UNITED STATES PATENT AND TRADEMARK OFFICE

APPLICATION NO.	FILING DATE	FIRST NAMED INVENTOR	ATTORNEY DOCKET NO.	CONFIRMATION NO.
10/712,286	11/12/2003	Robert J. Mills	14649	9293

Office Action Summary

DETAILED ACTION

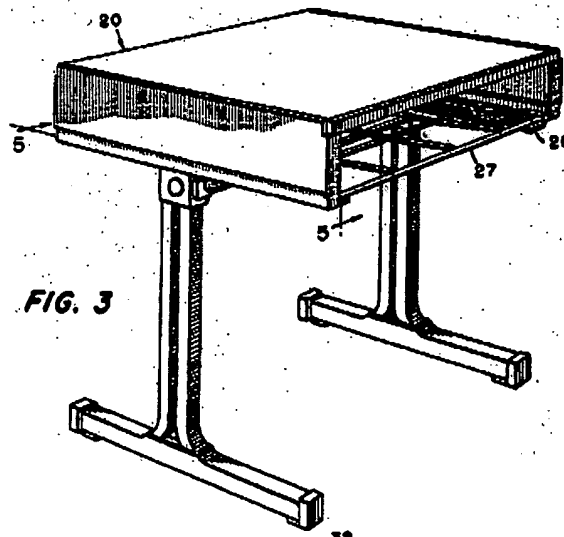
3. The drawings are objected to under 37 CFR 1.83(a). The drawings must show every feature of the invention specified in the claims. Therefore, the details of the first and second sections as shown in figures 1-3 must be labeled (following an updated description describing the elements as claimed) or the feature(s) should be canceled from the claim(s). No new matter should be entered.

Corrected drawing sheets in compliance with 37 CFR 1.121(d) are required in reply to the Office action to avoid abandonment of the application. Any amended replacement drawing sheet should include all of the figures appearing on the immediate prior version of the sheet, even if only one figure is being amended. The figure or figure number of an amended drawing should not be labeled as "amended." If a drawing figure is to be canceled, the appropriate figure must be removed from the replacement sheet, and where necessary, the remaining figures must be renumbered and appropriate changes made to the brief description of the several views of the drawings for consistency. Additional replacement sheets may be necessary to show the renumbering of the remaining figures. Each drawing sheet submitted after the filing date of an application must be labeled in the top margin as either "Replacement Sheet" or "New Sheet" pursuant to 37 CFR 1.121(d). If the changes are not accepted by the examiner,

Lundahl '743 Figure 1

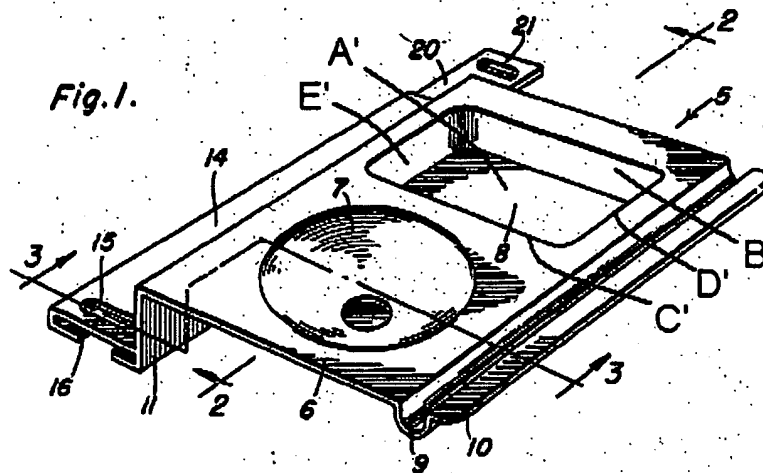
6. Lundahl teaches a pencil case (5) that has a portion (14) that is below the bottom of the typewriter (13) and the portion (14) is considered a bottom wall of the pencil case (5). The pencil case (5) has a first section (8) with a bottom wall (A'), opposing side walls (B', C'), a front wall (D'), and a rear wall (E'). The first section (8) is sized to retain a ruler or protractor within the walls. Rulers and protractors come in many sizes including some that are relatively small. Also note; a change in size is generally recognized as being within the level of ordinary skill in the art. *In re Rose*, 105 USPQ 237 (CCPA 1955). The pencil case is comprised of an upper compartment/ first section (8) and a lower compartment/second section (7). The lower compartment (7) is disposed next to or outside the typewriter (13). The second section (7) has a bottom wall and walls in the shape of circle and the circular wall is considered to be made of a front wall, a rear wall, and opposing side walls integral formed together. A third section (9) is higher than the first section and has a bottom wall, front wall, and a rear wall.

Rapp-Duncan '178 Figure 1

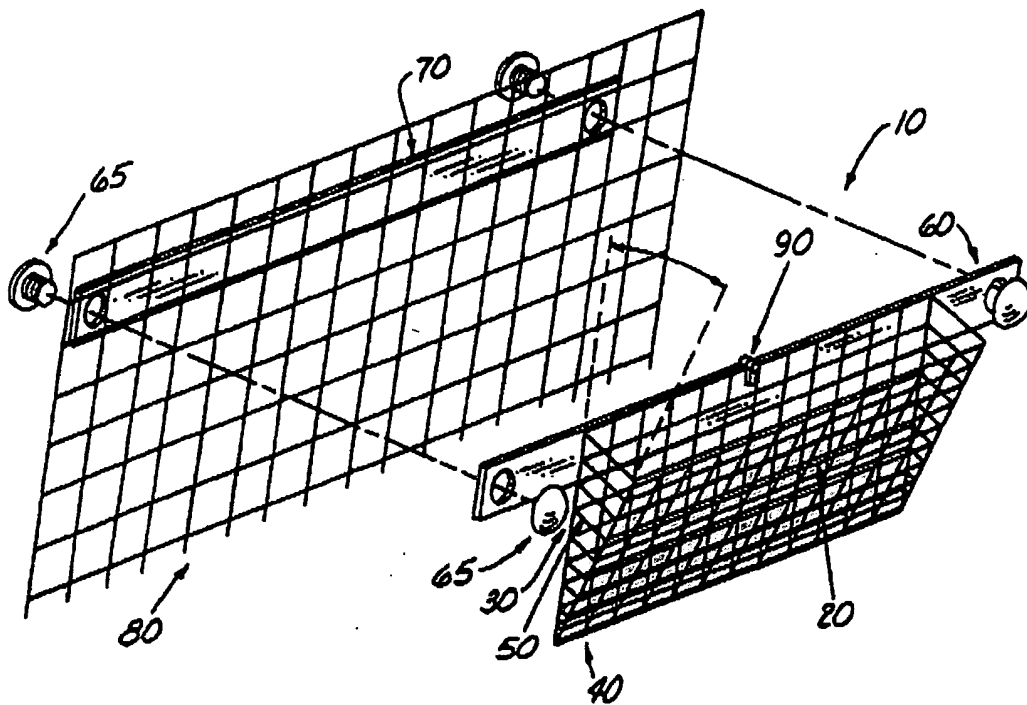
7. Rapp-Duncan teaches an auxiliary bin for a shopping cart. The shopping cart (80) is made form wire mesh. The bin (10) is made form a smaller wire mesh and is attached to a bar (60). The wire mesh shopping cart (80) is sandwiched between a attachment plate (70) and the bar (60) on the bin (10).
